RFP NO.: 619-012

ROCKVILLE CAMPUS PE POOL FILTRATION AND HEAT EXCHANGER REPLACEMENT

ADDENDUM #2

R-PH-5-ORIG-CONSTRUCT&ADDITIONS A-005
 PROJECT NO 3-5-00398-0
 CONN. No. 767
 DRAWN BY R.P.F. P.P.
 CHECKED BY R.P.H.
 DATE 09/13/10
 SHEET No.
A-5
 OF 41 SHEETS

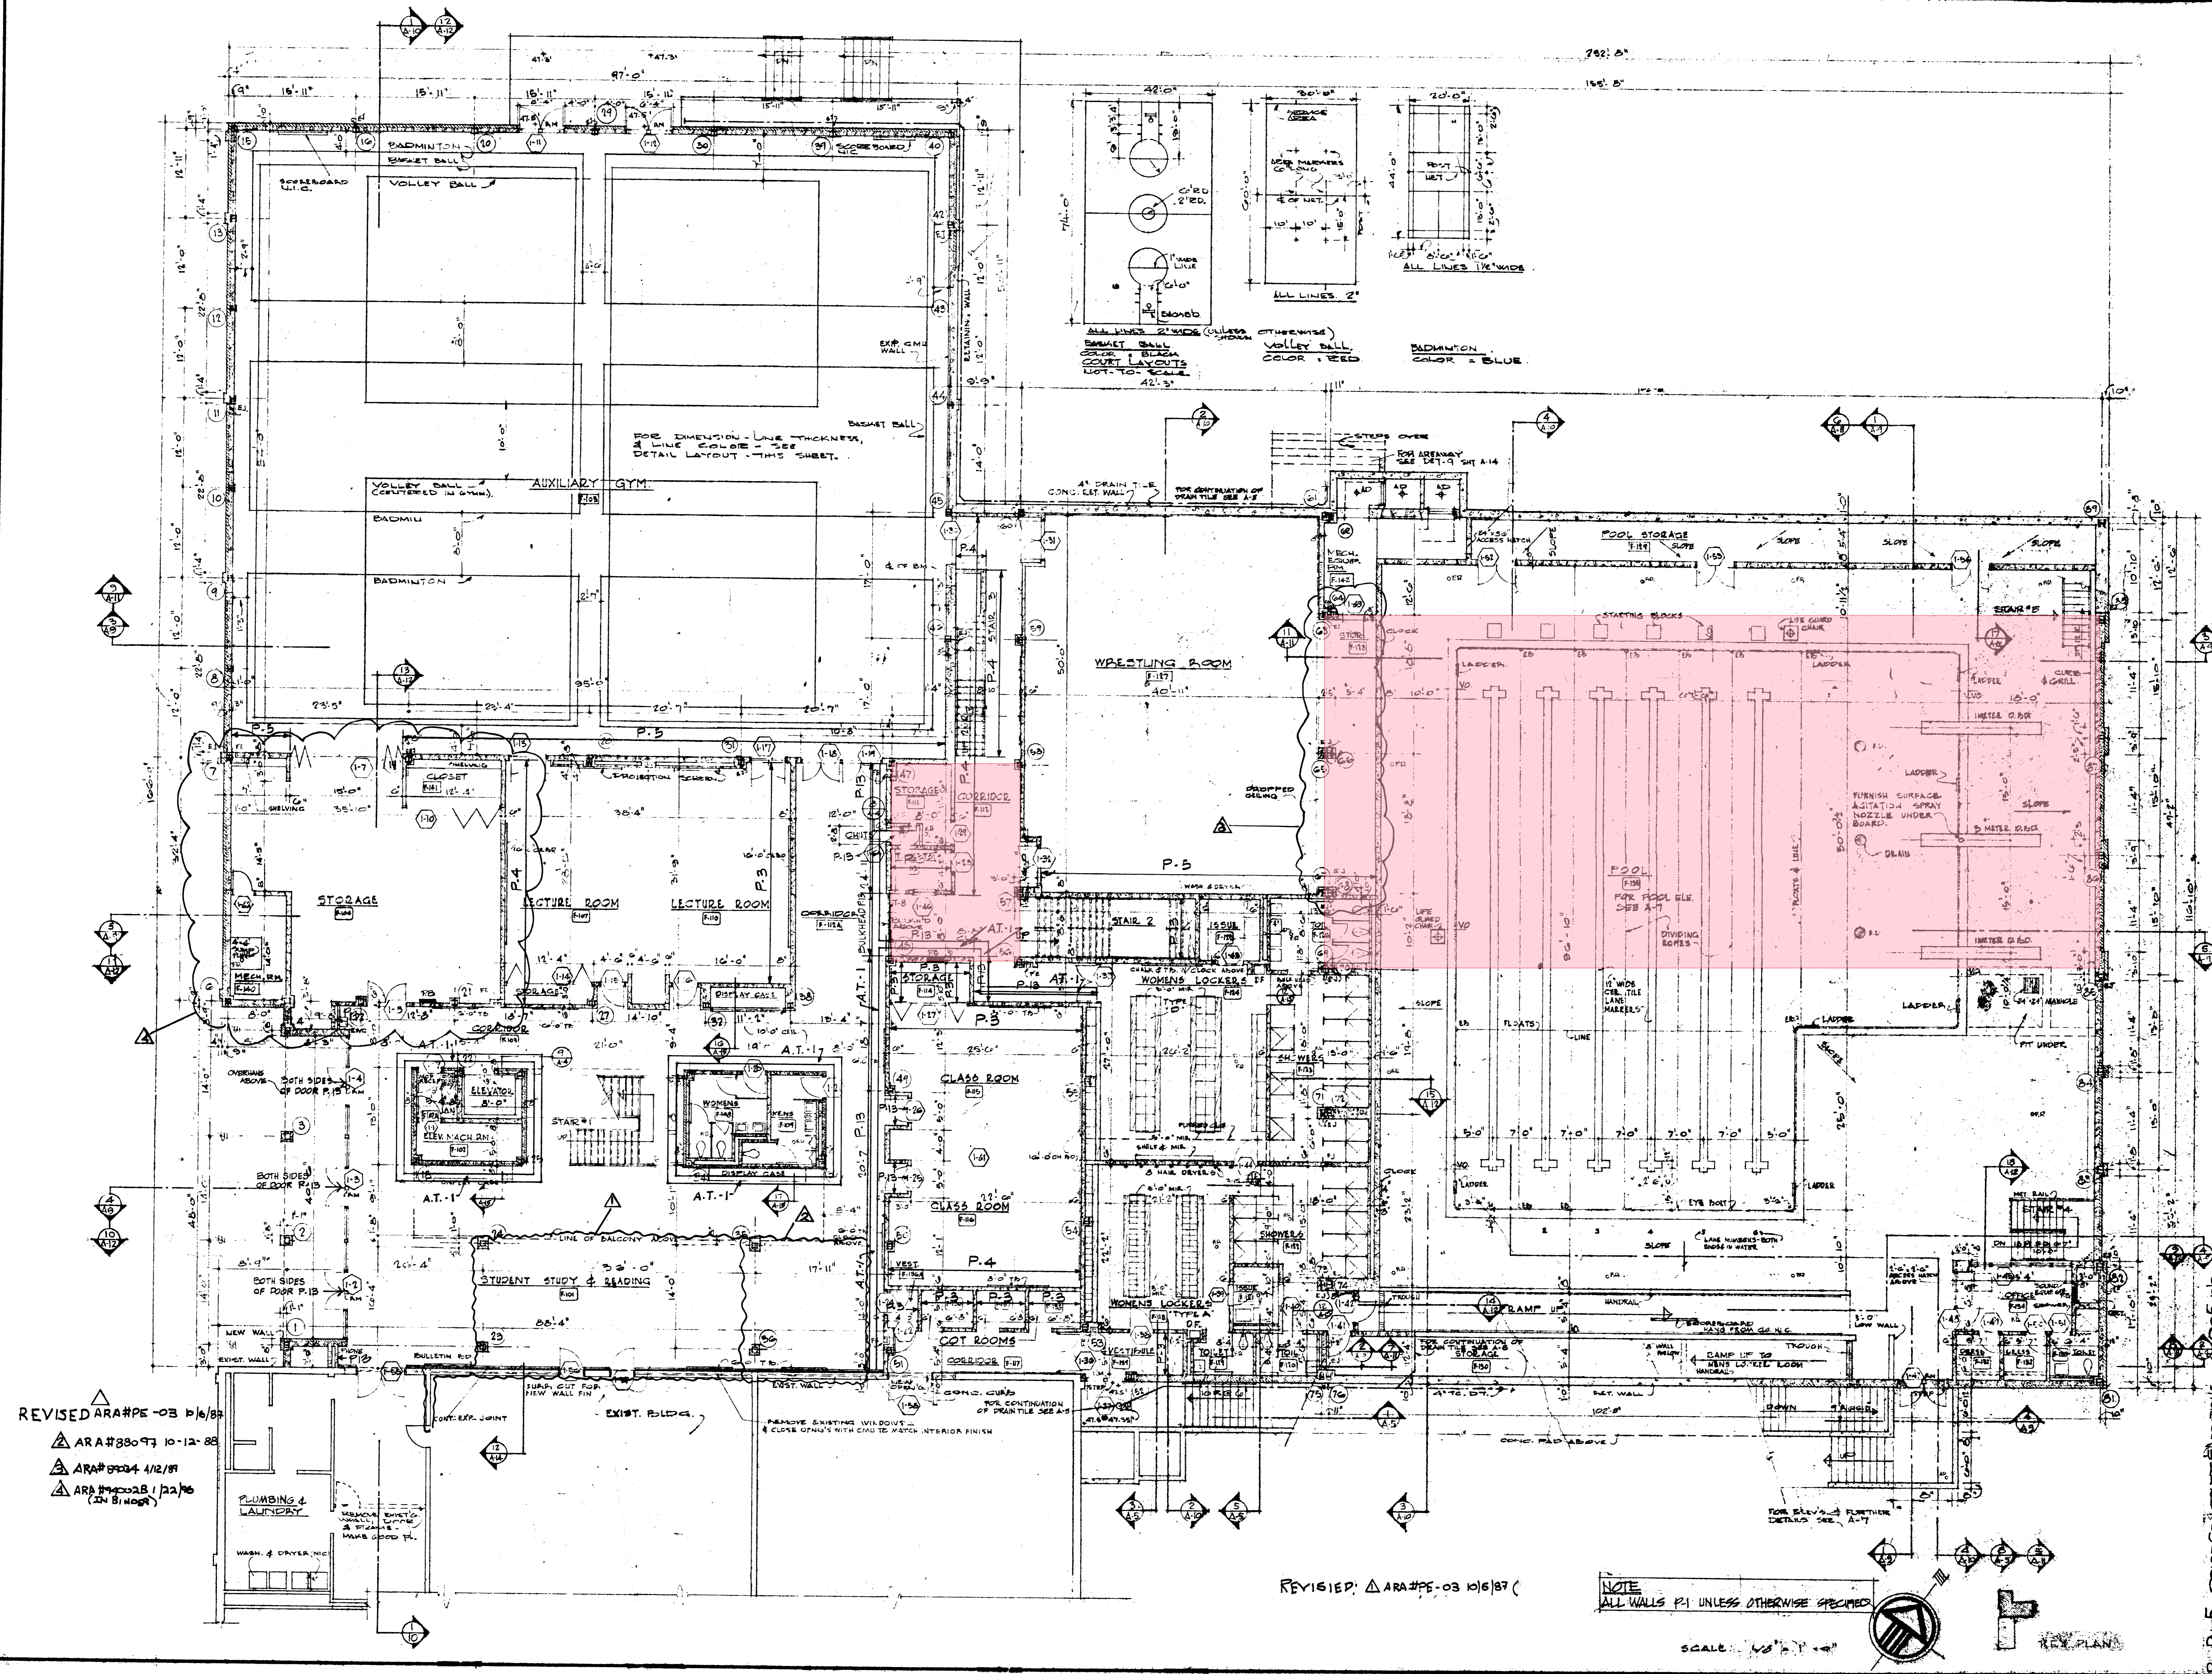
Item 2-1 Question: Drawing E2.01 indicates the location of the Penthouse above the pool area. On the site visit, the Penthouse is past the pool area quite a distance. Can a scale drawing be provided indicating the distance from the existing Panel PH to the Pool Filter Room?

Answer: The original construction drawings IS3, A5 & A6 are provided for reference.
